WAIVER REQUEST – RICHARDSON CROSSING *Revised 11.06.09*

Re: Richardson Crossing – Hearing 09-06
113 Central Street

The purpose of this letter is to describe the revisions made to the Plans for Richardson Crossing in response to comments made at the Public Hearing and Town Staff comments.

The purpose of this letter to inform the Board of revisions to the plans for Richardson Crossing made in response to the Engineering Departments IDC of January 14, 2010 and our meeting with Cory York earlier today.

Rear Façade Unit 1 Marsh View - 1/8" = 1'

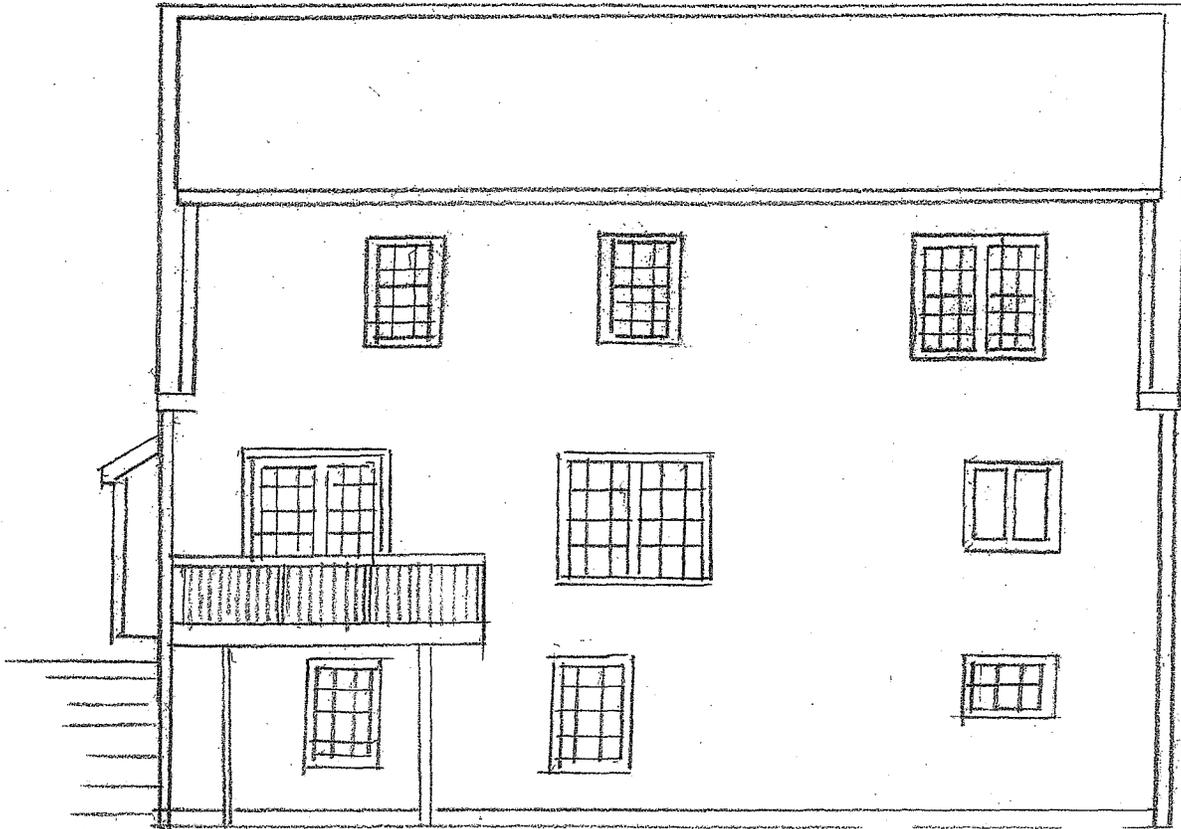
House 111 will be orientated to facilitate access from the common driveway and as a result the back of the house will be seen from Central Street. We are enclosing a copy of the rear façade of the Unit 1 at Marsh View, which is the mirror image of house 111.

The basement wall on the rear and garage side of the house will be wood framed and sided and trimmed with the same materials as the first and second floors.

House 111 will be located 42 feet from and 7 feet above the pavement of Central Street and these offsets will diminish the view

TREE LOST ANALYSIS

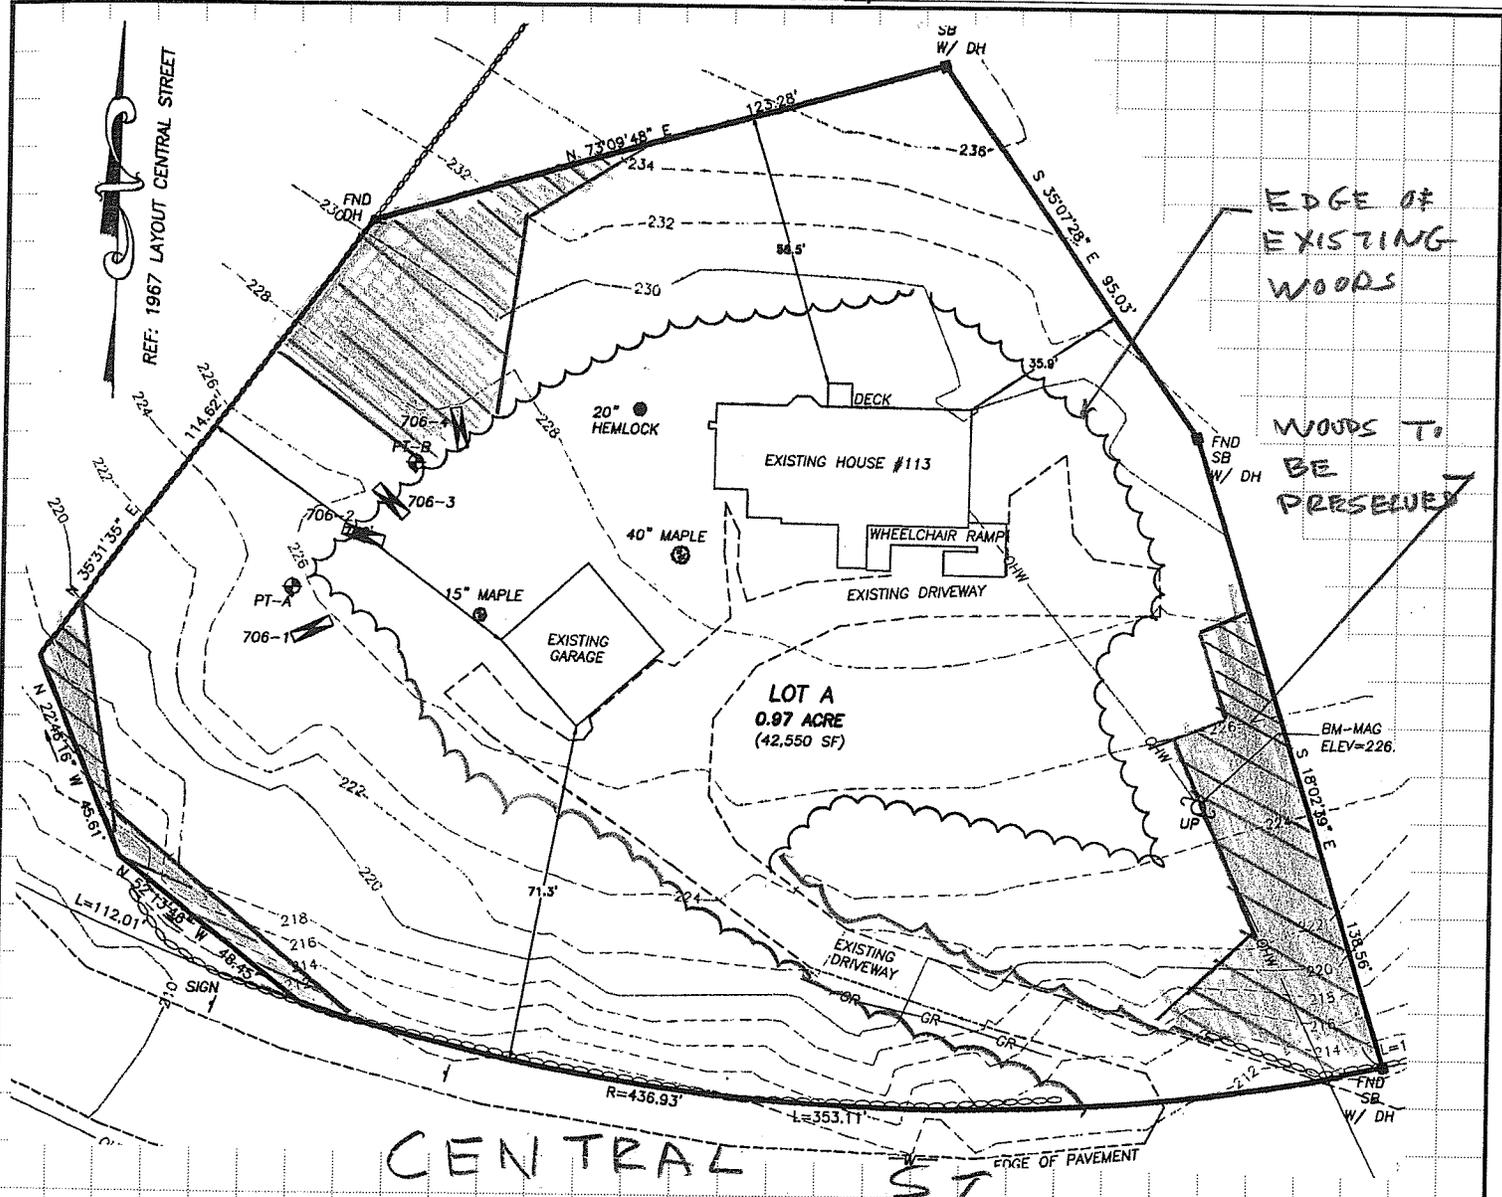
Tree Lost Analysis

We have calculated the existing area of woods to be 29,800 square feet or 70 percent of the site and 4,500 square feet of woods, or an area equal to 10 percent of the site, will remain as woods.

EXISTING WOOD AREA	≈ 29,800 SF
PROPOSED WOODS	≈ 4,500 SF
PERCENT OF SITE WOODED	
EXISTING	70%
PROPOSED	10%
